Access Compliance Report Public Rights-of-Way (Curb Ramps)

Main Street: NEWPORT_AVE Cross Street: ST_JOHN_PL Location: SE

ADA ID: RPAT211018101139 Ramp Type: Type 1 - Perpendicular Diagonal Initial Pass/Fail: Fail Overall Compliance: No Severity Score: 2

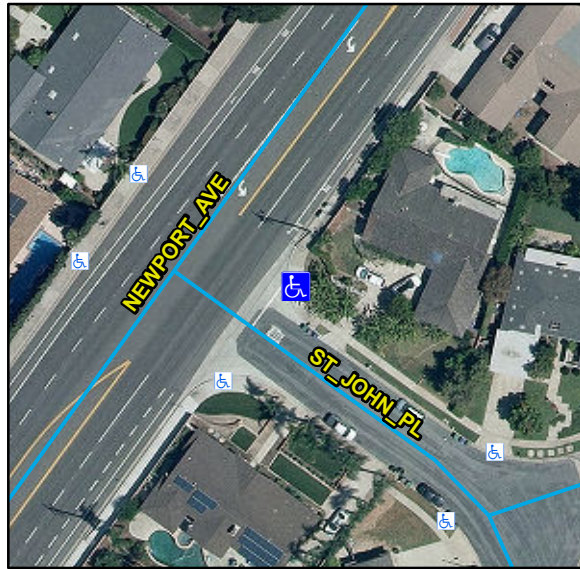
Compliance	Description	Data	Compliance	Description	Data
N/A	Ramp Length (in)	48	N/A	Flare Type LT	
Yes	Ramp Width (in)	48			N/A
Yes	Ramp Run Slope (%)	7.3	N/A	Flare Slope LT (%)	N/A
No	Ramp Cross Slope (%)	3.4	N/A	Flare Traversable LT	N/A
N/A	Landing Present	N/A	N/A	Flare Type RT	
N/A	Landing Length (in)	N/A			N/A
N/A	Landing Width (in)	N/A	N/A	Flare Slope RT (%)	N/A
N/A	Landing Run Slope (%)	N/A	N/A	Flare Traversable RT	N/A
N/A	Landing Cross Slope (%)	N/A	N/A	DWS Provided	N/A
N/A	Landing Movement Obstructed?	N/A	N/A	DWS Contrast	N/A
	Landing Movement Type	N/A	N/A	DWS Length (in)	N/A
N/A	Landing Shared	N/A	N/A	DWS Full Width	N/A
N/A	Clear Space	Yes	N/A	DWS Offset Left (in)	N/A
N/A	Clear Space To Crosswalk (in)	N/A	N/A	DWS Offset Right (in)	N/A
N/A	Marked Crosswalk 1	No	N/A	Marked Crosswalk 2	No
	Crossing 1 Direction	NW		Crossing 2 Direction	SW
	Marked Crosswalk 1 Width (in)	N/A		Marked Crosswalk 2 Width (in)	N/A

Remove & Replace Curb Ramp With Two New Directional Ramps or Equivalent. Replace Spandrel.
